Design Review Board Study Session

SUBJECT: DR14-05, SALAD AND GO

DR14-05 Salad and Go: master site plan, parcel site plan, landscape plan, grading and drainage, elevations, floor plans, lighting, colors and materials, located east of the southeast corner of Higley and Williams Field Roads zoned Community Commercial (CC) with a.

EXTERIOR ELEVATIONS

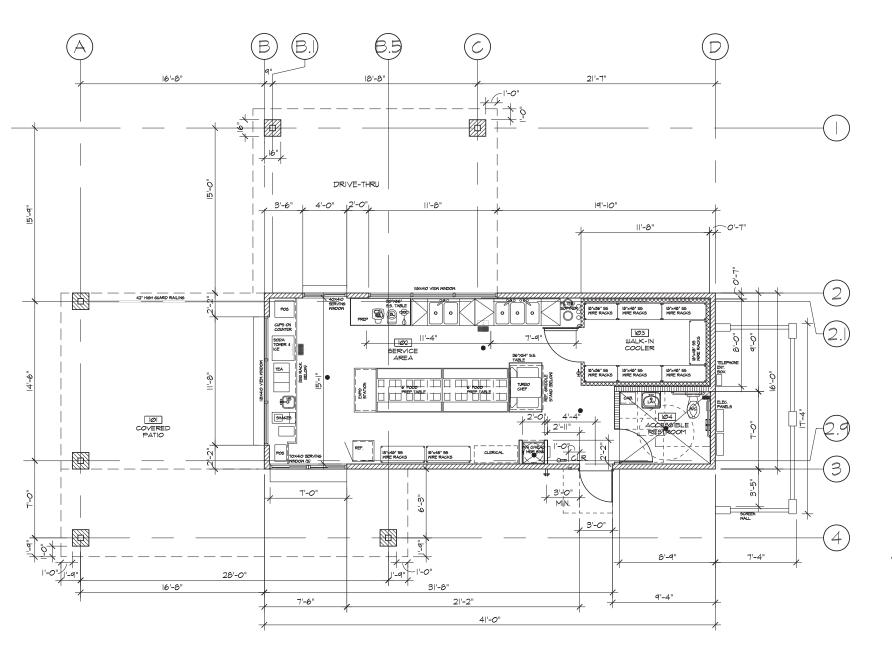
The proposed building elevations are the same as the elevations previously approved for the Salad and Go location at Gilbert and Guadalupe Roads, and Cooper and Warner Roads. The infill site is governed by an approved color palette for the shopping center. Staff suggests changing the proposed Celtic White to Angora, which matches the approved field color.
